# Delaware River Basin Flood Analysis Model Independent External Peer Review Report

Prepared for:  
Federal Emergency Management Agency, Region III  
Delaware River Basin Commission

January 6, 2012

**Figure 1. Jadwin Reservoir plot for the September 2004 event (source: HEC, 2011).**

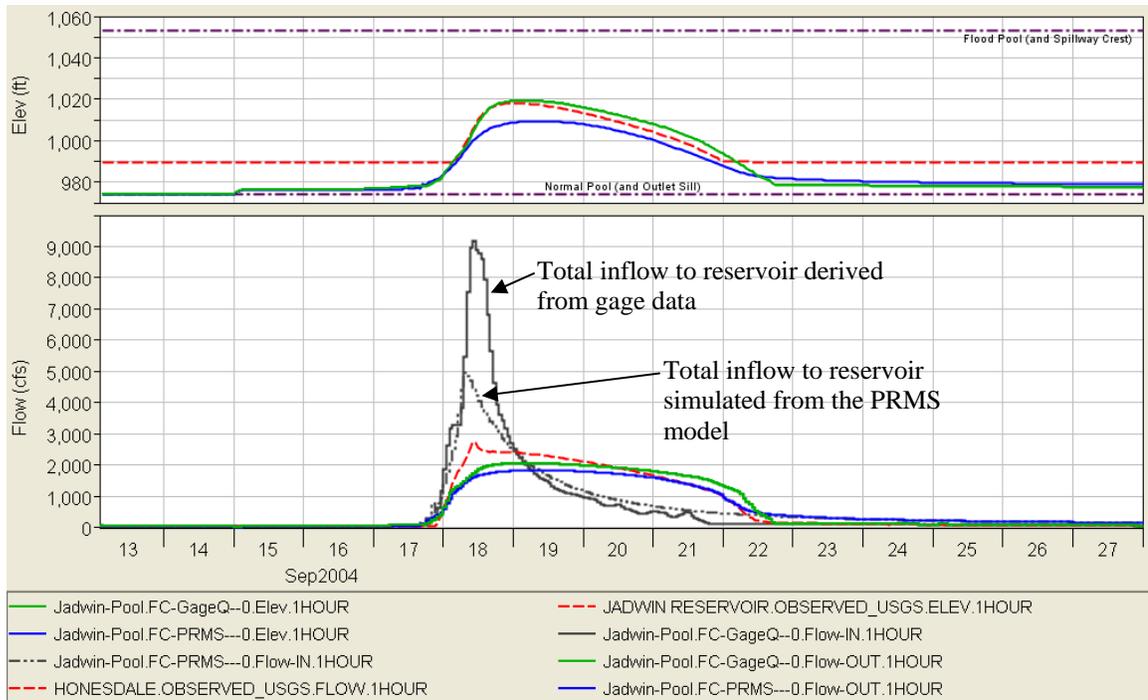
- c. As described in the HEC-ResSim modeling report (Section 5.1, Page 63, HEC, 2011), the PRMS-generated inflows were first used in the HEC-ResSim model (Alternative FC-PRMS). However, the HEC-ResSim model did not satisfactorily reproduce the peak flows or total volumes that occurred during the flood events. A second inflow data set had to be derived using observed flow data and used in the HEC-ResSim model (Alternative FC-GageQ). This alternative more closely reproduces the peak flows and total volumes that occurred. Figure 1 and Figure 2 are two examples that are taken from the HEC-ResSim modeling report. The figures clearly illustrate the significant differences in the inflows that were generated from the PRMS model and that were derived from the observed flow data.

**Figure 3. Reach editor for Stilesville to Hale Eddy Reach.**

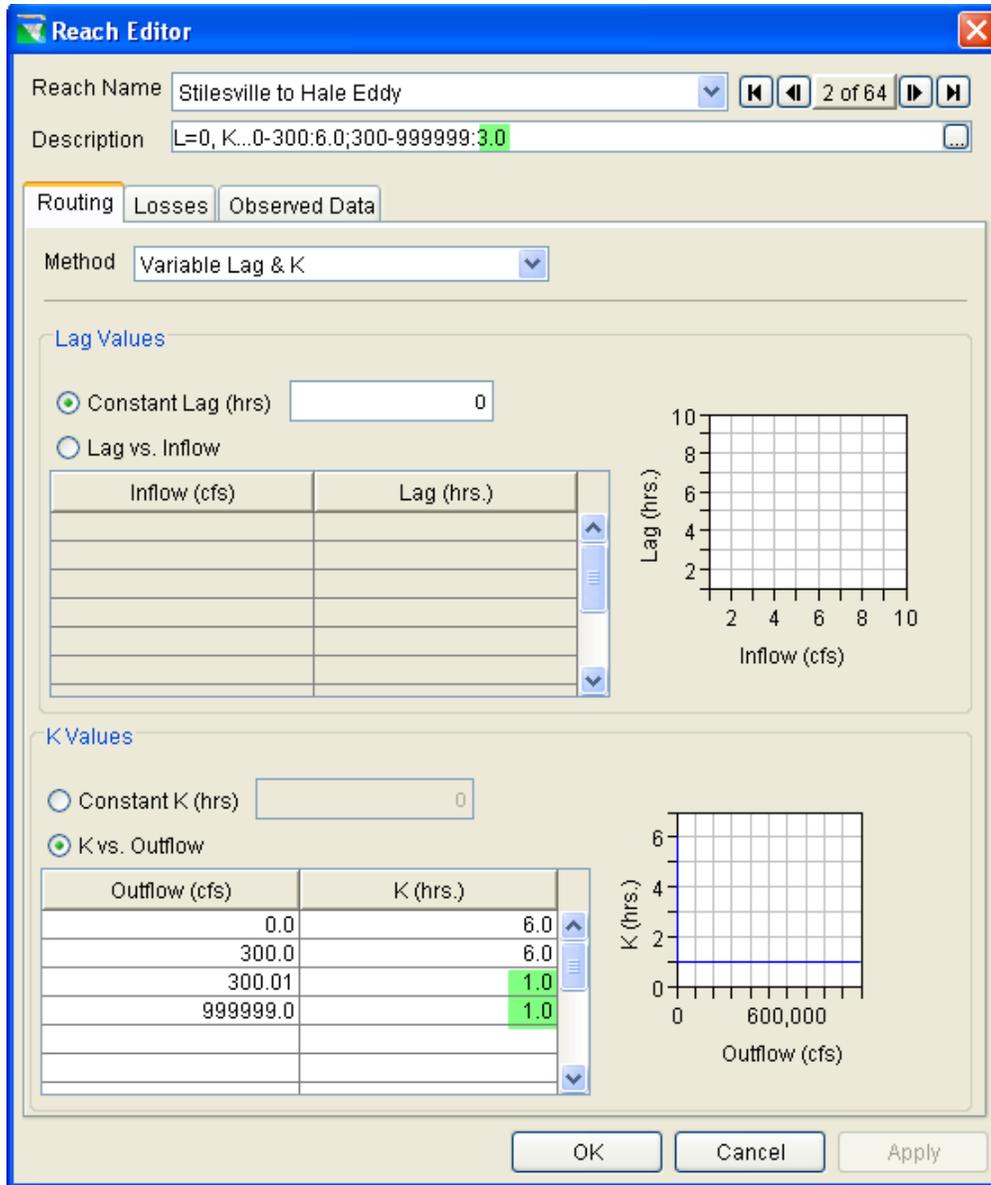
10. Comment - Page 27, Table 4.6. The K value is 1.0 hour when outflow is greater than 300 cfs (see Figure 3). The second row in Table 4.6 and the description in the model need to be corrected.

Comment Response - Agreed. Report updated.

Back-Check Comment – Nonconcur. The description in the model remains to be corrected.

Figure 4.4 Observed Releases from Pepacton Reservoir and Observed Discharge at Harvard selected that provided the best estimate of travel time from all three flood events.

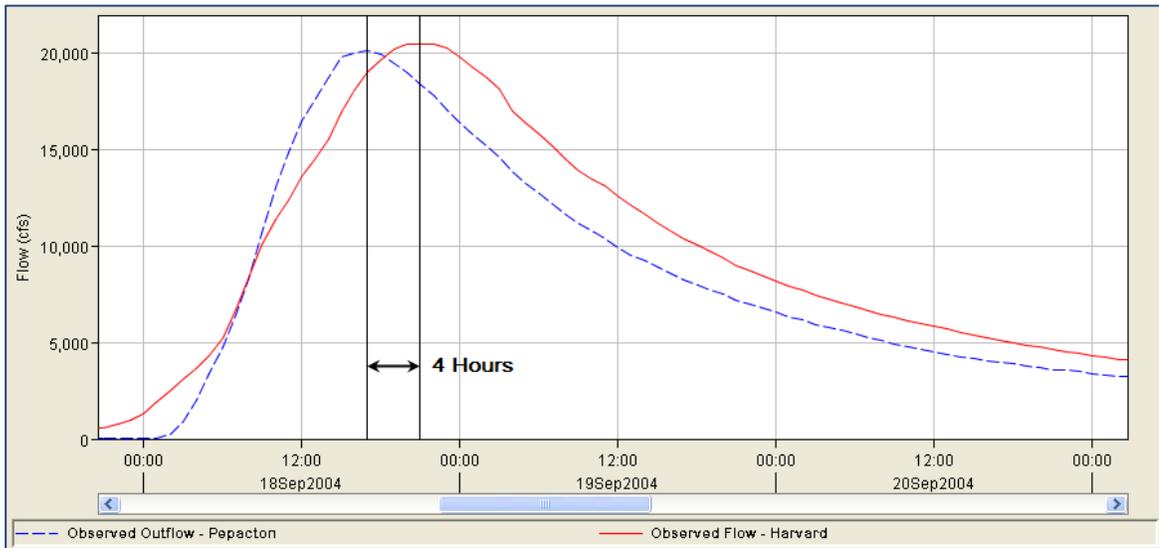
b. Comment - Suggest including details of how the parameter values for the Muskingum method were estimated.

Comment Response - The following text was added to the report and Tables 4.6 through 4.10 were updated with final routing parameters.

The Muskingum K parameter was determined by: a) using the Lag routing parameters provided by the NWS; and, b) evaluating the time of peak flows at upstream and downstream gaged locations for the three historic events modeled in this study. In most reaches, the Lag parameter provided by the NWS varies as flow rate increases. As mentioned above, the HEC-ResSim model parameters were developed to route major flood flows; therefore, the smallest lag parameter (corresponding to flood flows) from the array of Lag and Flow provided by the NWS was selected as the best estimate for the Muskingum K parameter. Figure 4.4 can be used to illustrate how observed hydrographs were also used to estimate the Muskingum K parameter. This figure shows the observed discharge hydrograph from the Pepacton Reservoir and the observed discharge hydrograph at the Harvard stream gage for the 2004 flood event. The lag time of the

peak flow for these two hydrographs is approximately 4 hours. The 2005 and 2006 flood events were also evaluated to determine travel times. One Muskingum K parameter was

The Muskingum X parameter is typically set by calibrating the model to observed discharge. It was found in most reaches that the Muskingum X parameter needed to be set to a relatively small value, 0.1, in order to provide adequate attenuation of the peak flow within the routing reach. These reaches generally occurred downstream of the Belvidere junction on the Delaware River and the Bethlehem junction on the Lehigh River. The Belvidere and Bethlehem junctions contain the last observed discharge until the Trenton junction (most downstream point in the HEC-ResSim model). For all three flood events, 2004, 2005, and 2006, the combined discharge at the junction of the Delaware and Lehigh Rivers was slightly larger than the observed discharge downstream at the Trenton gage; therefore, the Muskingum X was set to 0.1 to model the appropriate amount of attenuation in the downstream reaches.

Back-Check Comment – WEST concurs with the text added to the report. The report now clearly describes the Muskingum method and how the parameters were estimated.

Figure 4. Reach editor for Bridgeville to Godeffroy Reach.

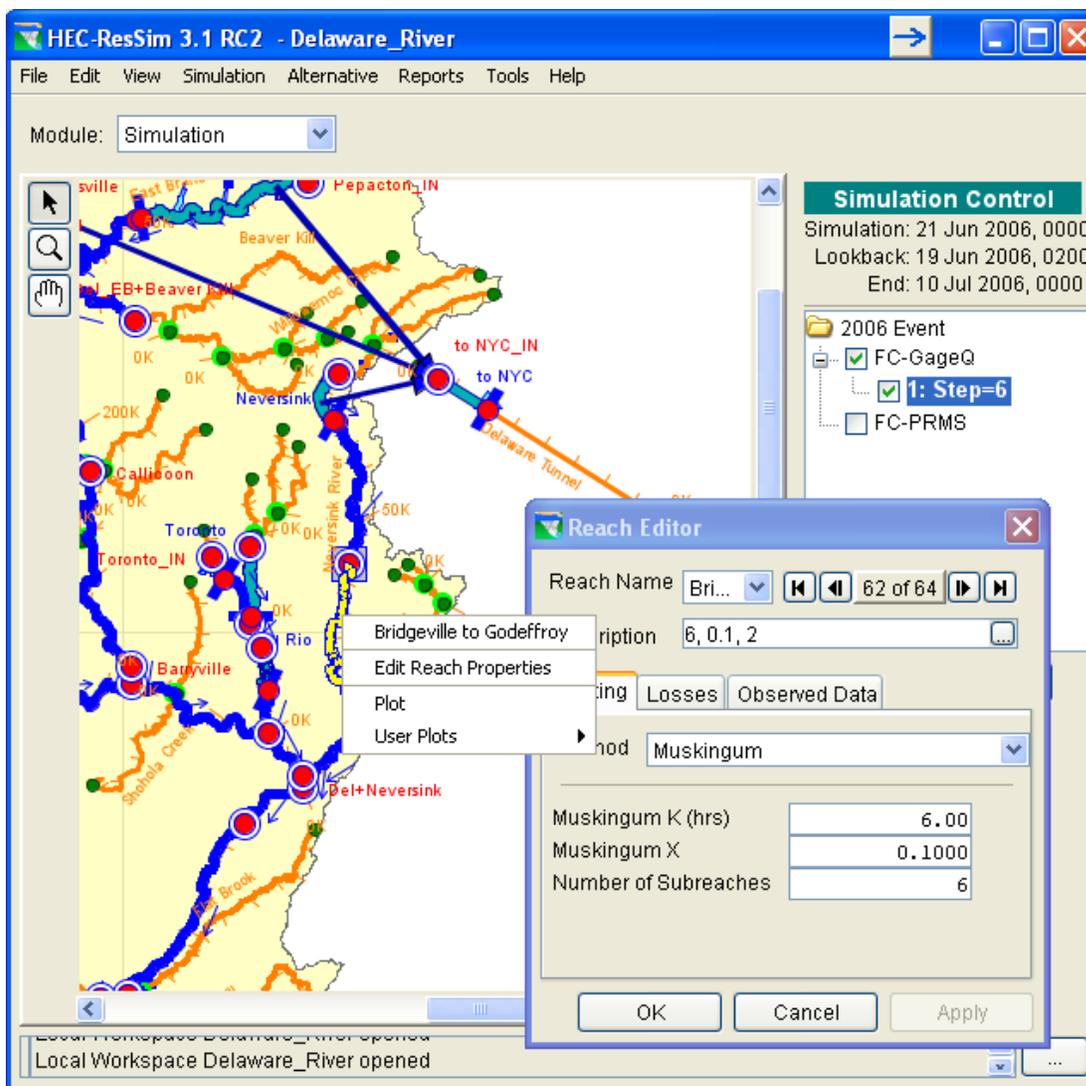
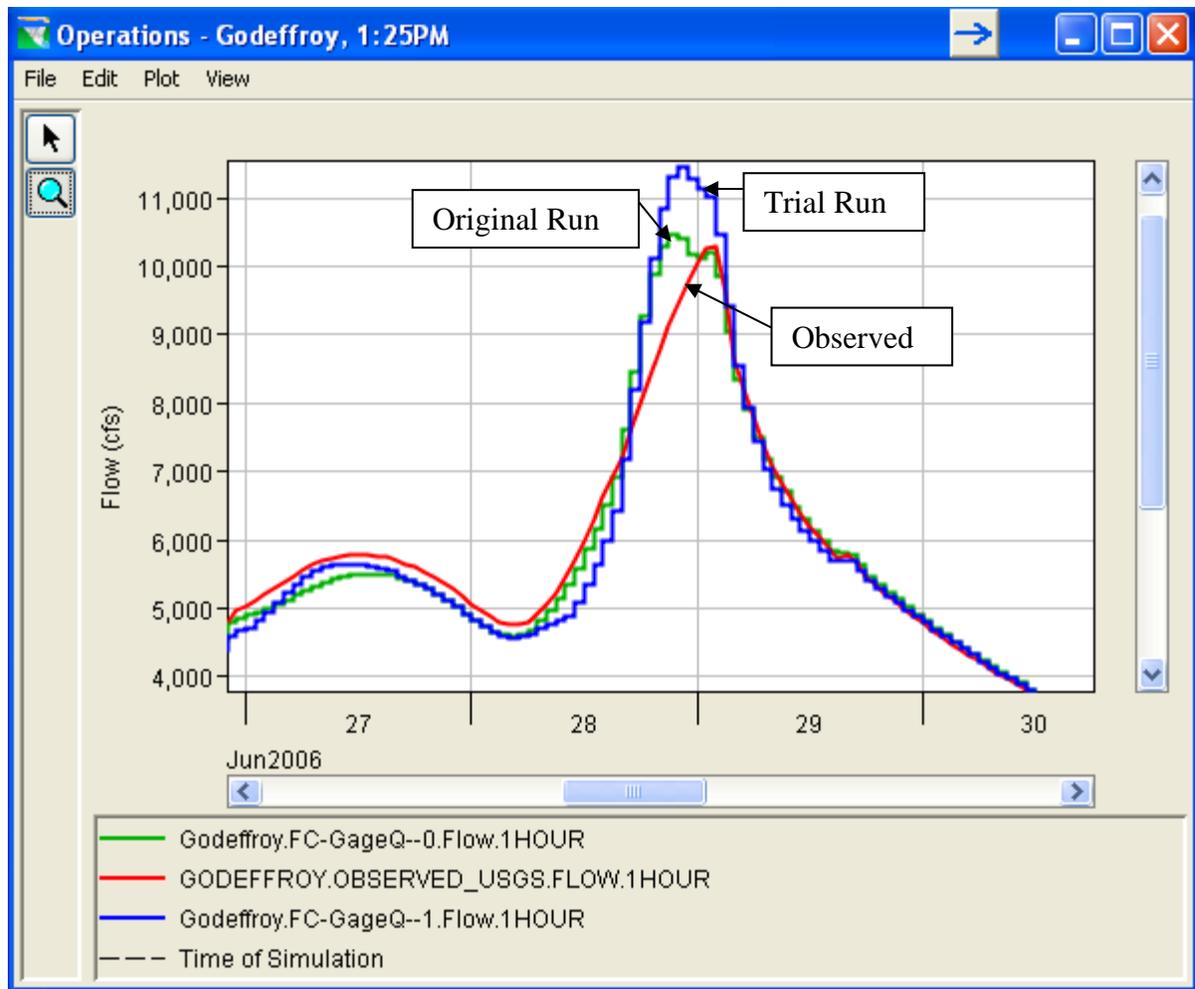
c. Comment - According to the guidance described in HEC-ResSim User Manual (Page 9-8, HEC, 2007), the number of subreaches should be approximately equal to travel time, which is the Muskingum K parameter, divided by the computation time step. Since the computation time step is one hour, the number of subreaches should be equal to the K value numerically. However, the numbers of the subreaches in Table 4.6 through Table 4.10 are significantly different from the K values for many reaches that use the Muskingum routing. We did a sensitivity run by increasing the number of subreaches from 2 to 6 for Bridgeville to Godeffroy Reach (Figure 5). The results for the June 2006 event indicate that the model is sensitive to the number of subreaches (Figure 5).

Comment Response - Just like the Muskingum X parameter, the number of subreaches affects the amount of attenuation in the routed flood hydrograph. The number of subreaches is a calibration parameter, as stated in the HEC-HMS Technical Reference Manual on page 80. Figure 3 in the Reviewers Notes is a great example of how sensitive the routed hydrograph is to the number of subreaches and why the number of subreaches should be treated as a calibration parameter. This is one reason why the user has the option to adjust this parameter in both HEC-ResSim and HEC-HMS when calibrating the model to observed hydrographs. The HEC-ResSim User's Manual should be updated providing similar guidance to the HEC-HMS Technical Reference Manual. As stated in bullet b above, text was added to the report describing how the number of subreaches was estimated for the HEC-ResSim model.

Back-Check Comment – Concur.

**Figure 6. Rating curve at Minisink Hills**

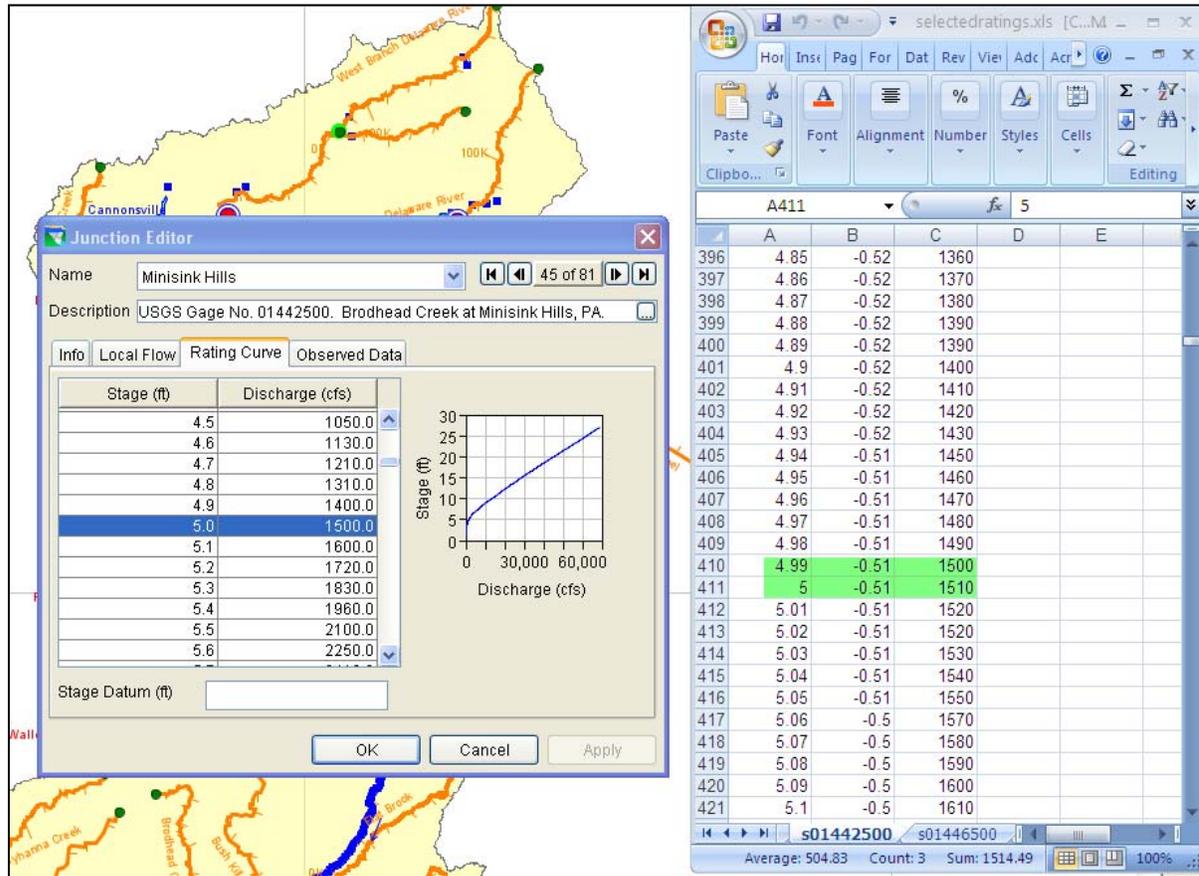
25. Comment - Model. Rating Curve at Minisink Hills (USGS Gage No. 01442500). Starting at stage 5.0 ft, the discharge values are slightly off compared to the raw rating curve provided by USGS. The discharge of 1,500 cfs in the model actually corresponds to stage 4.99 ft (see

Figure 6).

Comment Response - The rating curves used in the model were supplied by our project partners at the USGS and were expected to represent the (average) state of the rating at the time of the three events. Since a given rating could have changed during or after each event, the ratings should be considered approximate or averaged and would not likely match a current rating for any gage in the model.

**Figure 7. Raw rating curve at USGS Gage No. 01442500.**

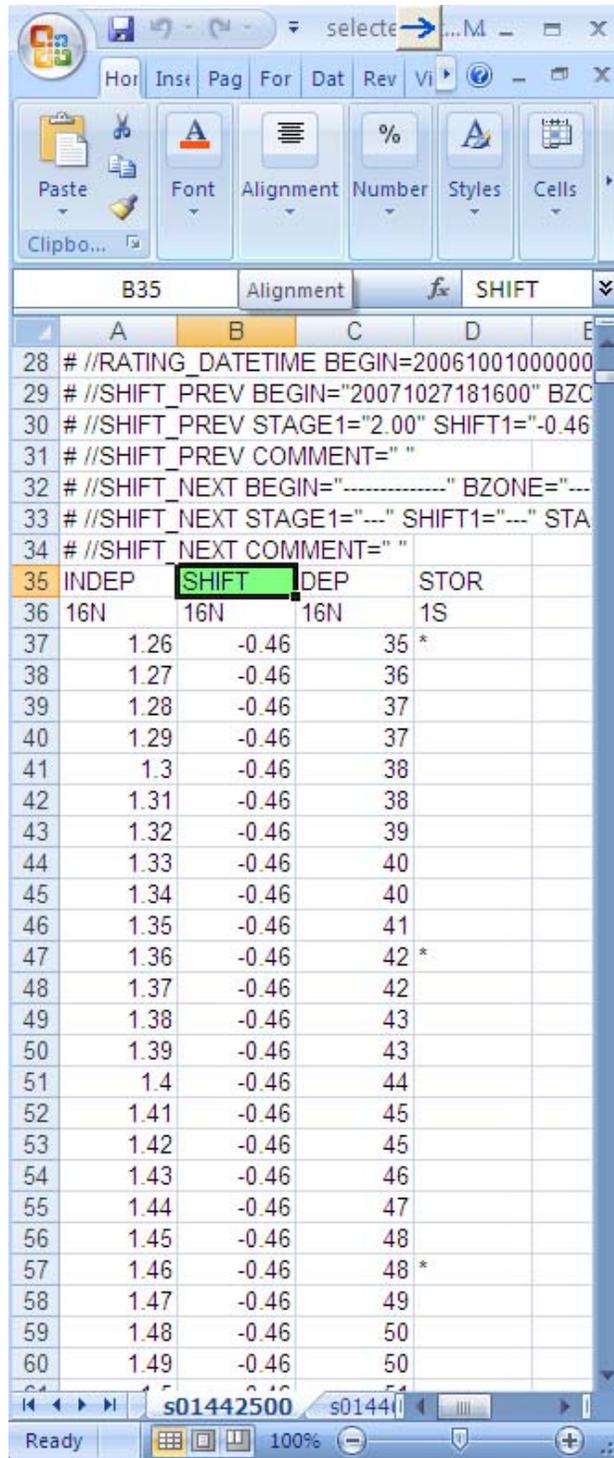
26. Comment - Model. Rating Curves. The raw rating curves provided by USGS at Minisink Hills (Gage No. 01442500), Shoemakers (Gage No. 01439500), Port Jervis (Gage No. 01434000), and Cooks Falls (Gage No. 01420500) have non-zero shift values in the second column (see an example in Figure 7). What do the shift values mean? Is there a need to shift the rating curves?

Comment Response - As illustrated in your figure 5, the rating data published by the USGS website ("<http://waterdata.usgs.gov/nwisweb/data/ratings/exsa/USGS.%s.exsa.rdb>") includes 3 columns of information labeled INDEP, SHIFT, and DEP respectively. INDEP is short for independent variable and represents the stage measurement at the gage. DEP is short for dependent variable and represents the expected (or computed) associated flow for the

**Figure 8. Observed flow hydrograph at Walnutport (USGS Gage No. 01451000) in HEC-DSS format.**

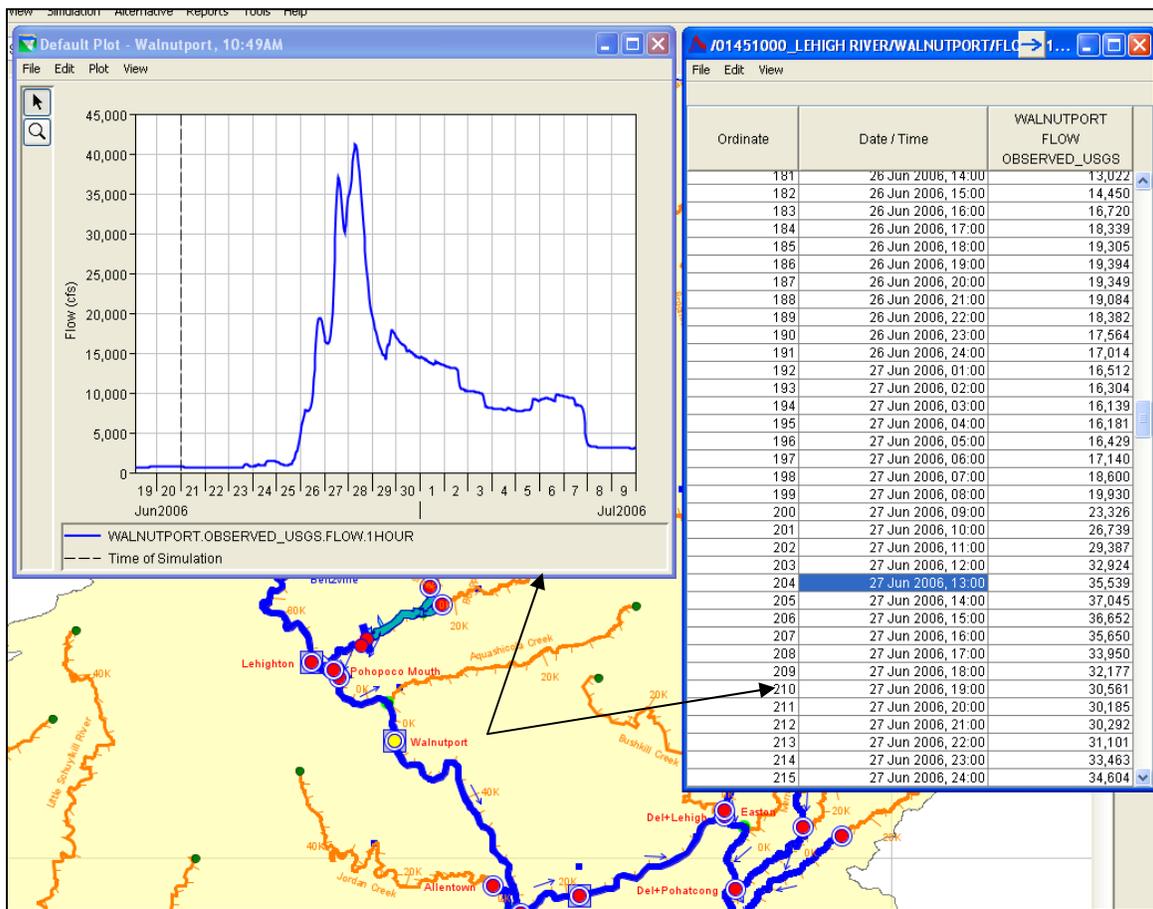
27. Comment - Observed Flow Data. The watershed time in the model is defined as Eastern Standard Time (EST). By reviewing the HEC-DSS records for the observed flow data, which were used for model calibration and testing, and comparing them to the data downloaded from the USGS Instantaneous Data Archive, we found that the conversion from raw data to HEC-DSS records might not consider the time shift from Eastern Standard Time (EDT) to EST. The examples in Figure 8 and Figure 9 show that the discharge at 13:00, EST, June 27, 2006 should be 37,045 cfs, instead of 35,539 cfs.

Comment Response - The observed data mapped into the model came from a variety of sources, but the two primary sources were our project partners at the USGS and our contacts at the DRBC. In both cases, the data was supplied in either comma separated text files or in MS Excel workbooks. The method we used to get the data to DSS was to put everything into

Back-Check Comment – The data as they were provided might be in local time (either EST or EDT). The new version of DSSVue has an option to convert from DST to standard time. WEST believes that this issue is minor as the observed flow hydrographs were not used to develop/calibrate the model. The 1-hour shifts are likely not noticeable when the results are plotted for the entire durations of the events, which are 2 to 3 weeks.
